**Flood Control Project Maintenance
Levee Inspections**

Maintenance Issue Types Only, Levee Inspection Report By Mile - Spring 2018

Levee District No. 0003 (Glenn County)

Waterway	Bank	Unit Miles	Inspection Start/End	Inspector
Unit No. 01 Glenn County Sacramento River	Left	11.97	03/09/2018 03/09/2018	Bob Duffey

Photo 1 of 1 : SP_2018_LD0003_27_35_20180305_00019.jpg

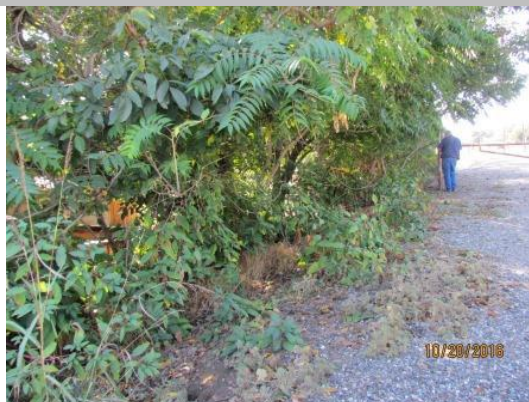
LM Start	6.75	Rating **	M	Issue No.	35
LM End	6.75	Issue Type +	Ma	Location *	LS
Category	Earthen Levee			GPS Latitude/Longitude	
				Start	End
Item	Trim / Thin Trees			39.465013 °	39.465013 °
				-121.991455 °	-121.991455 °
DWR ID	DWR_LD0003_01_s_2012_35				
Comment Code					
T1 : Trim trees to at least five feet above ground level.					
Inspector Comment

View of the trees that are hanging over the landside slope of the levee.

Photo 1 of 1 : SP_2018_LD0003_27_47_20180305_00024.jpg

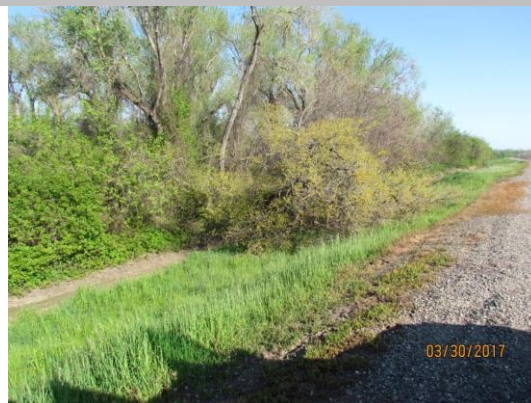
LM Start	6.91	Rating **	M	Issue No.	47
LM End	6.91	Issue Type +	Ma	Location *	WS
Category	Earthen Levee			GPS Latitude/Longitude	
				Start	End
Item	Encroachments			39.467358 °	39.467358 °
				-121.991333 °	-121.991333 °
DWR ID	DWR_LD0003_01_s_2017_47				
Comment Code					
TR : Tree or limb					
Inspector Comment					
Remove the tree from the waterside slope and toe.

View of the tree on the waterside slope and toe.
